## MR #2023016 – BOWIE MILL ROAD BIKEWAY

### Description

NO. MR2023016

Item No. 7

Figure 8: Proposed Guardrail along Muncaster Mill Road

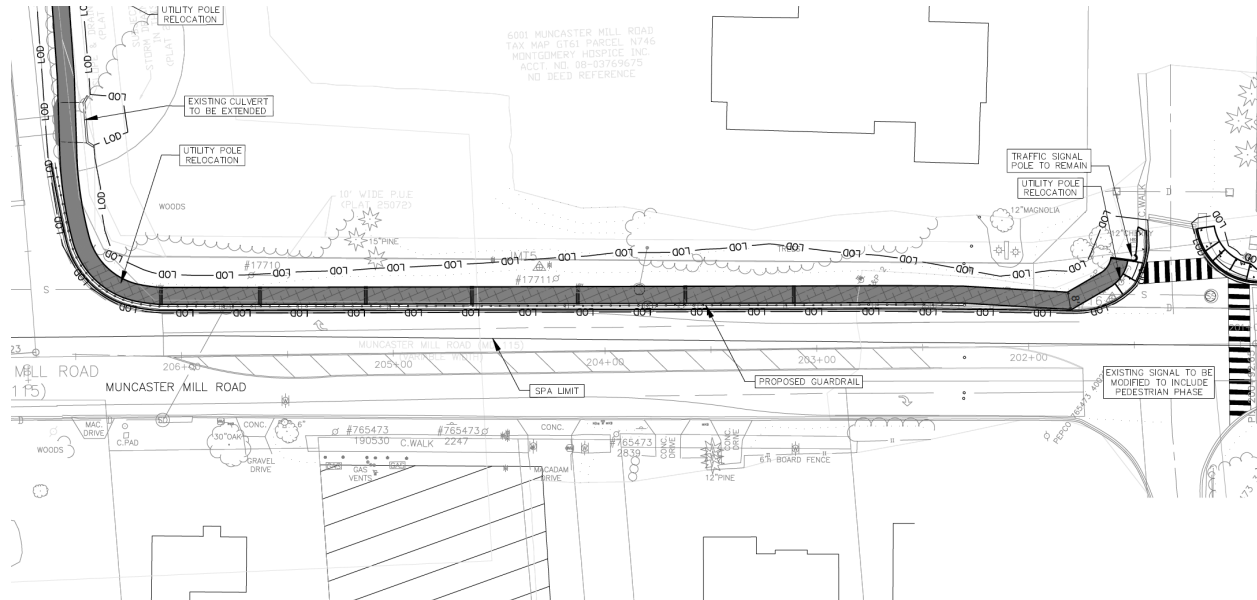
**Recommendation: Ensure vertical obstructions, including utility poles, fences and guardrails, are at least two feet from the edge of the sidepath.**

Between Stations 202+00 on Muncaster Mill Road and 1+00 on Bowie Mill Road, there is a proposed guardrail immediately adjacent to the eight-foot sidepath (Figure 8). This vertical element narrows the effective width of the sidepath to six feet, which is too narrow for bicyclists to safely pass each other or to pass pedestrians. A two-foot buffer should be provided between this guardrail and the sidepath.

Figure 9: Example Utility Pole Locations Next to Proposed Sidepath

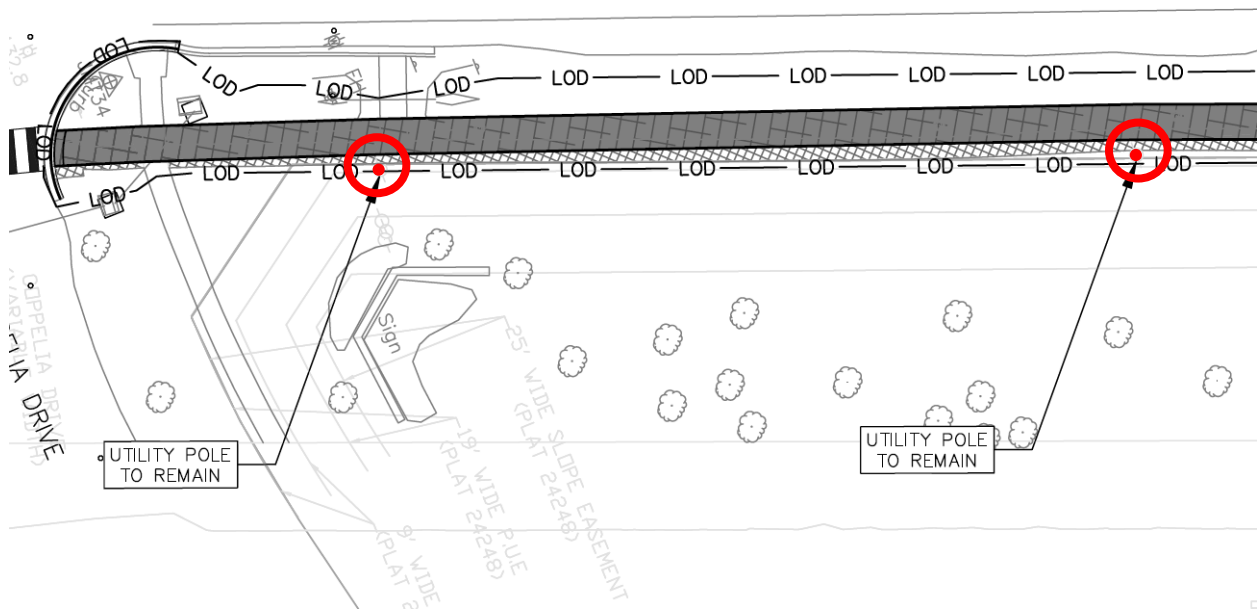
At the following Stations within the project limits, existing utility poles appear to be close to the sidepath (Figure 9):

1. 8+00
2. 10+00
3. 12+00
4. 13+50

- 5. 15+00
- 6. 17+00
- 7. 18+50
- 8. 128+00

Ensure that these utility poles are at least two feet from the sidepath. If not, consider shifting the sidepath or relocating the utility poles as appropriate to maintain the two-foot separation.

Figure 10: Sidepath with Curb Ramp Concern

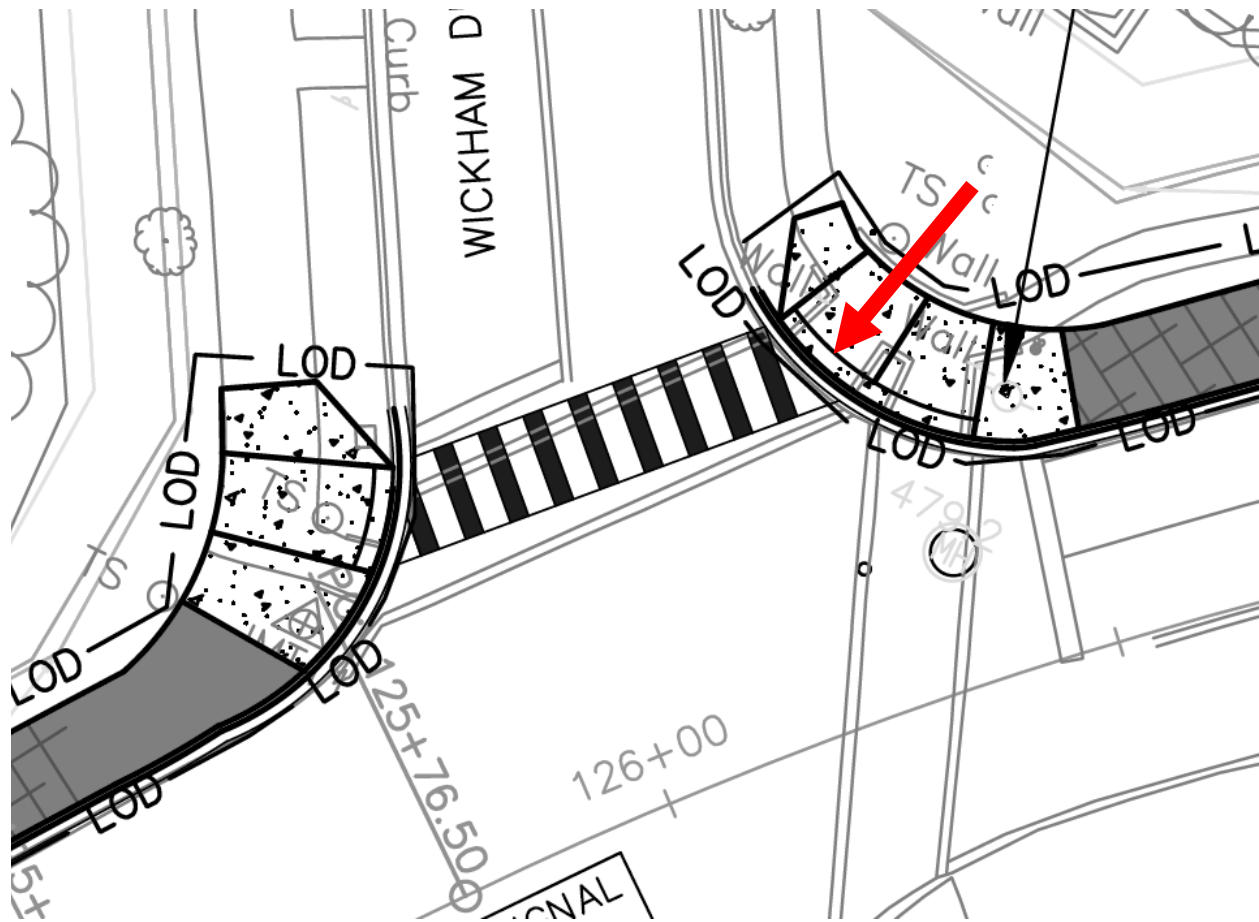
**Recommendation: Provide directional curb ramps that are aligned with high-visibility marked crosswalks at all street crossings, including at Stations:**

Directional curb ramps aligned with marked crosswalks are a best practice because they guide pedestrians along the shortest path across the street or driveway, reducing pedestrian exposure to traffic. When curb ramps are oriented toward the middle of an intersection (Figure 10), people with low or no vision and those using wheelchairs or other mobility devices can be directed to cross the street outside of the intended path of travel.

Figure 11: Thornhurst Drive Intersection without Connection to Neighborhood to the South

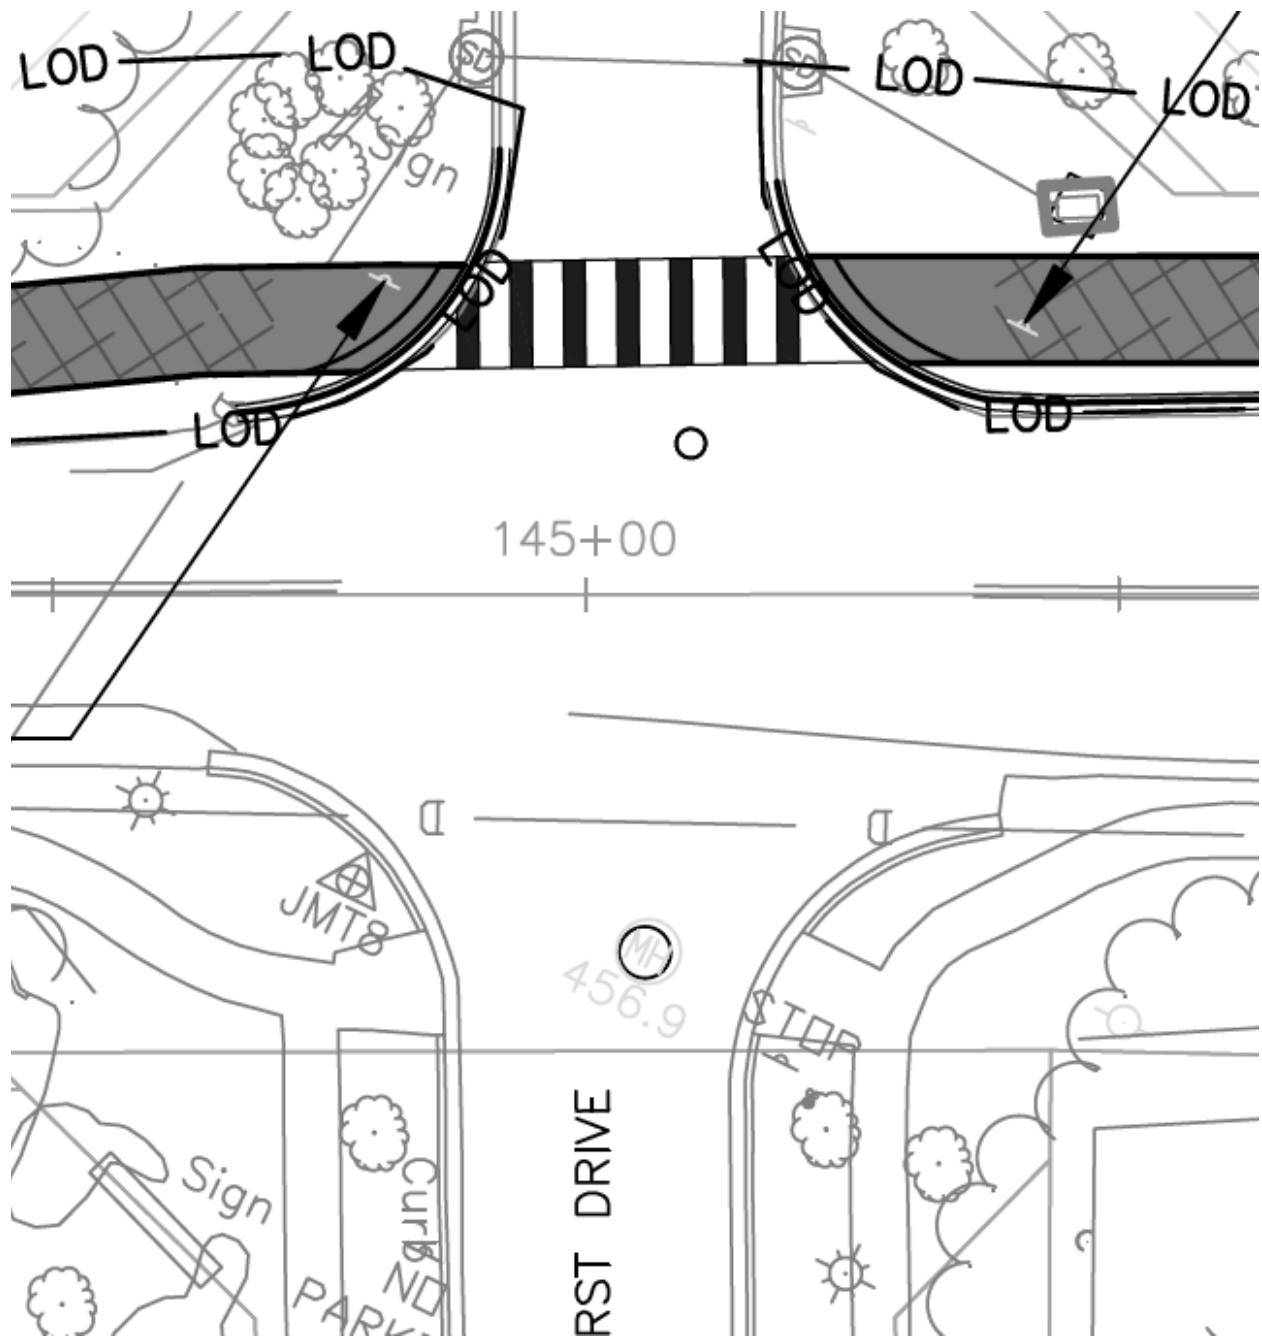
There are three intersections within the project extent that connect to residential subdivisions on the opposite side of Bowie Mill Road from the proposed sidepath without either a connecting marked crosswalk or a protected crossing.<sup>2</sup> An example of this issue is at Thornhurst Drive (Figure 11), which lacks a protected crossing across Bowie Mill Road.

At this location and others, the project team should explore providing protected crossing features to ensure residents can safely access the sidepath and sidepath users can safely access adjacent communities.

Figure 12: Missing Bus Stop at Sequoyah Elementary School

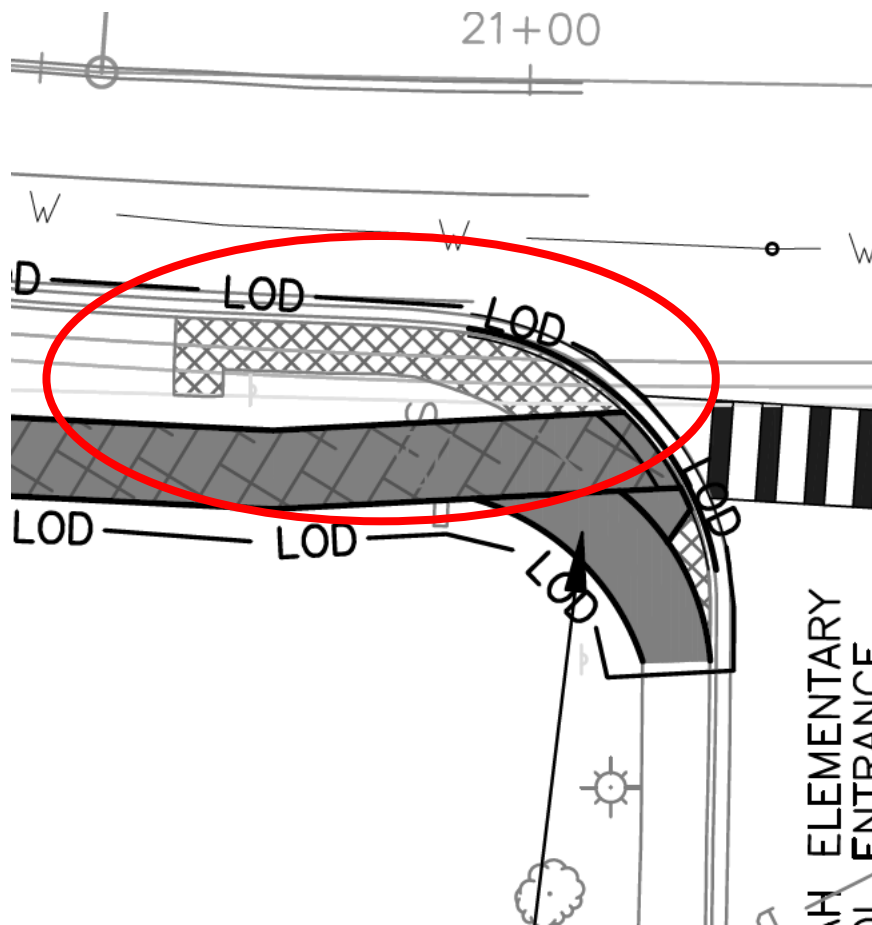
**Recommendation: Replace missing bus pad at Sequoyah Elementary School.**

At the Sequoyah Elementary School bus stop (21+00), the paved pad where transit riders board and alight from buses appears to be missing. It appears in Google Streetview imagery but is shown as removed without replacement in Figure 12.

Figure 14: Bowie Mill Road at Foggy Lane

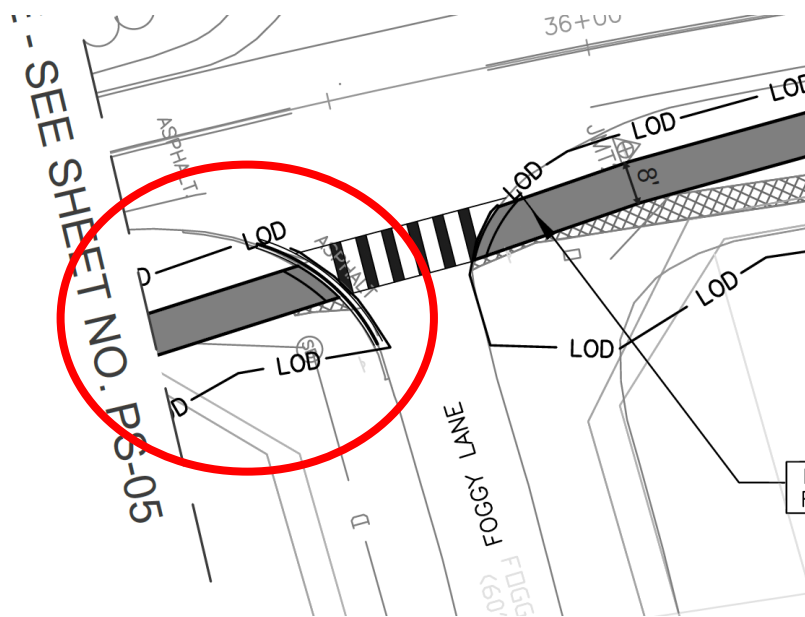
**Recommendation: Tighten curb radii at all intersections and driveways in line with the Complete Streets Design Guide (CSDG) default radii (15 feet). Where wider turning radii may be helpful for larger vehicles or emergency operations, consider the use of mountable curbs or relocating the receiving leg stop bar to allow for encroachment.**

Additionally, the smaller the curb radius, the less roadway pedestrians have to cross, reducing their exposure to conflict. Figure 15 illustrates the turning radius issue at the circled corner of the intersection with Foggy Lane, but radii across the corridor should be tightened to the extent possible.

Figure 18: Abrupt Sidepath Shift East of Sequoyah Elementary School

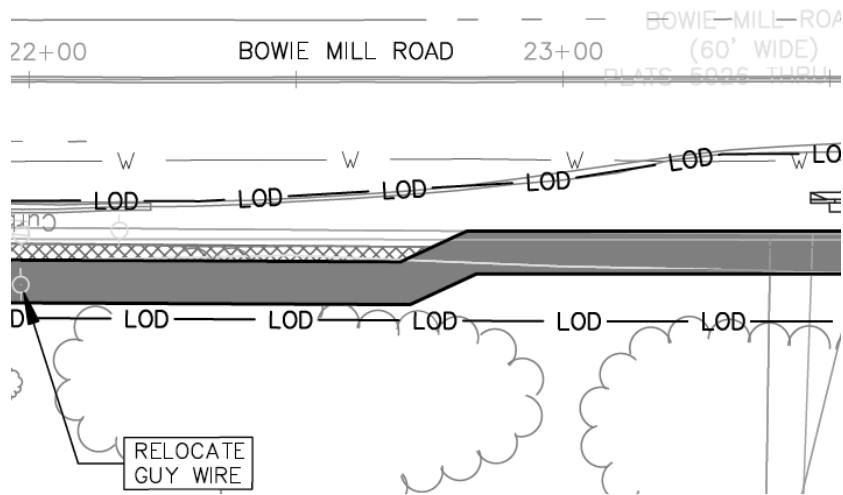
**Recommendation: Smooth abrupt shifts in the sidepath alignment at Stations:**

There are several locations where the sidepath shifts horizontally in a manner that may be unsafe for users, particularly bicyclists. Figure 19 identifies one such location. The *Bicycle Master Plan* Bicycle Facility Design Toolkit indicates that the maximum “lateral taper” or horizontal shift should be at a 3:1 ratio or one foot horizontal for every three feet along the sidepath. The project team should ensure that all changes in horizontal sidepath alignment are not more aggressive than 3:1.

Figure 19: Northern Sidepath Terminus

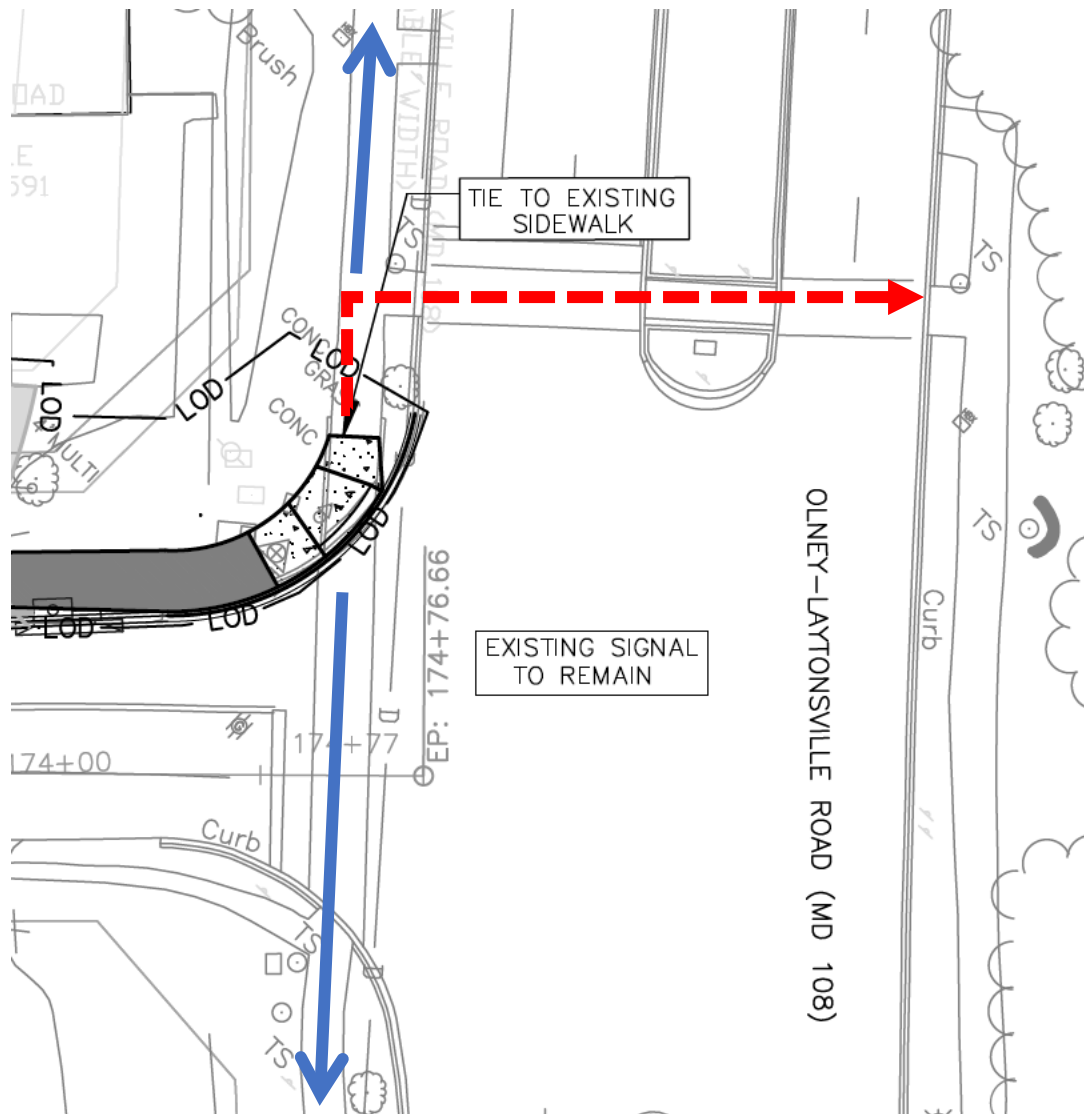
**Recommendation: Extend the Bowie Mill Road sidepath to the pedestrian crossing at Olney-Laytonsville Road so that it connects with the existing sidepath along the north side of Olney-Laytonsville Road.**

As currently designed, the proposed sidepath ends at the corner of Bowie Mill Road and Olney-Laytonsville Road as shown in Figure 20. Bicyclists would want to cross Olney-Laytonsville Road to use the sidepath along its north side (the dashed red path in the figure below) will have to use a 25-foot-long section of sidewalk to access the crossing, creating a potential pinch point for users. To mitigate this conflict, the proposed project should be extended to this protected crossing location at sidepath width.

Figure 20: Narrow Sidepath with Minimal Buffer

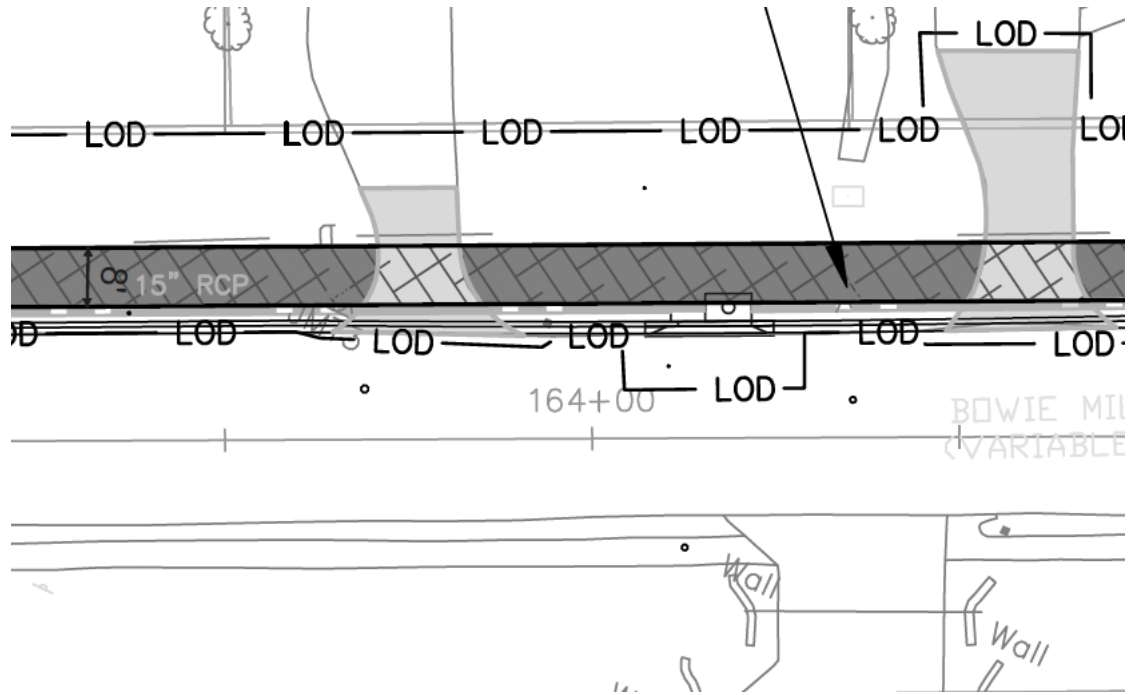
**Recommendation: Explore opportunities to provide a wider sidepath and street buffer between the sidepath and Bowie Mill Road between Briars Road and Olney-Laytonsville Road.**

Between Briars Road and Olney-Laytonsville Road, the sidepath narrows from the standard ten feet for areas outside of Special Protection Areas to eight feet, and has a one to two-foot-wide street buffer, as shown in Figure 20. Reducing the width of the sidepath and the street buffer as it nears Olney-Laytonsville Road Center is problematic, as Planning staff would expect more walking and bicycling at this end of the sidepath given the proximity to Olney Town Center. At the same time, a wider street buffer is preferred to minimize the likelihood of bicyclists or pedestrians unintentionally entering the roadway. The default street buffer width for this street type (Area Connector) will be six

feet in the coming update to the CSDG. Further project design should investigate widening the sidepath and street buffer, with a preference for a wider street buffer if both are not possible.

Figure 26: Area of Perpetual Easement for MCDOT Right-of-Way at North Branch SVP 3

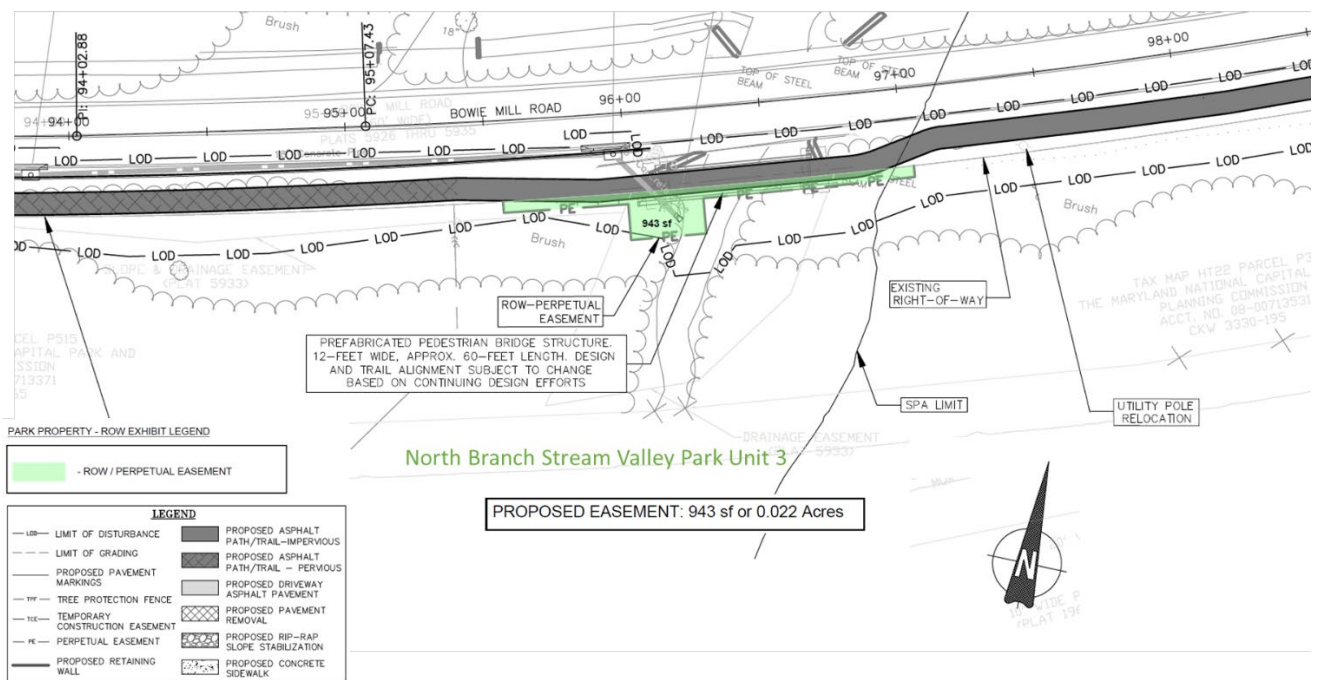
**Recommendation: Any approved Commission parkland such as North Creek Stream Valley Unit 3 to be added to the Montgomery County Department of Transportation Road right-of-way (ROW) will be transferred to the County, as appropriate, via perpetual easement. The Commission must be paid the fair market value of the perpetual easement prior to the issuance of a Park Construction Permit.**

The permanent impact will result in the creation of additional MCDOT right-of-way totaling 943 square feet (through the granting at fair market value of a perpetual easement) from North Branch Stream Valley Park Unit 3 (Figure 27).
